1964 Corvette: Engineering Service Letter: Increased Capacity Fuel Pump

Subject: Increased Capacity Fuel Pump

Model and Year: 1964 Corvette 365 - 375 HP Engine And/Or Air Conditioning

Source: Chevrolet Technical Service Department - Field Service Engineering - 1964 Product Data Book

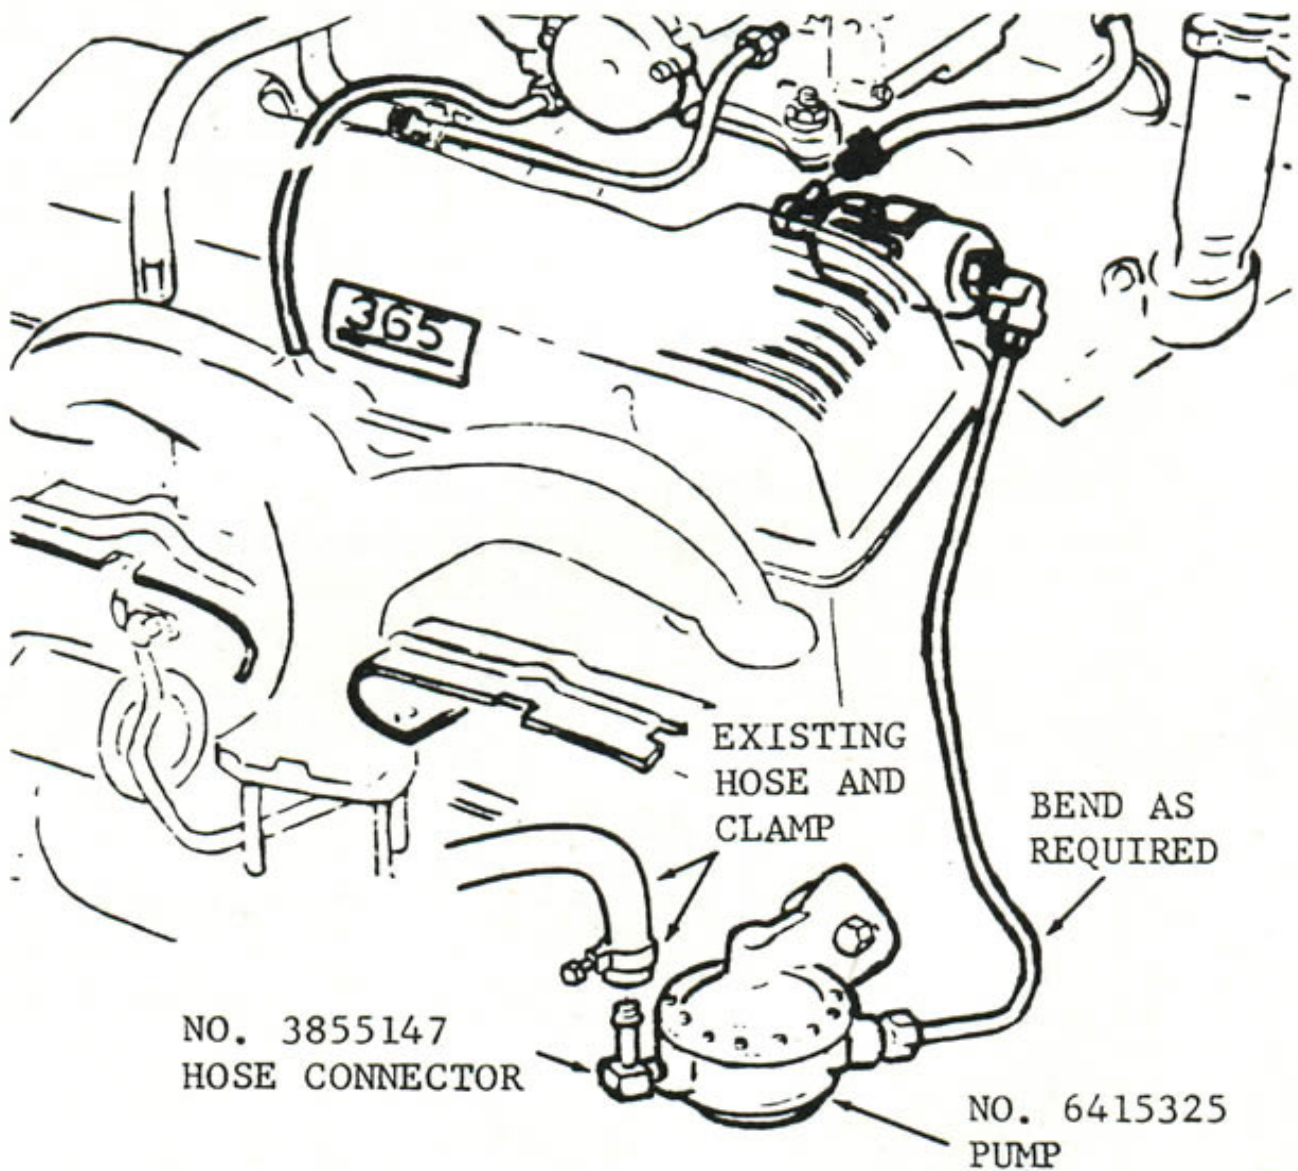
Corvettes with high performance engine options and/or air conditioning may experience a fuel vapor lock condition during high ambient temperatures. To eliminate this possibility, a new high capacity fuel pump is used on late production units with the subject options. The new high capacity pump includes vapor bleed holes in the inlet and outlet valves.

To install the new design pump on early production Corvettes, replace the existing pump with part number 6415325 Pump and part number 3855147 hose connector elbow. Bend the existing gas line as required to match the outlet fitting.
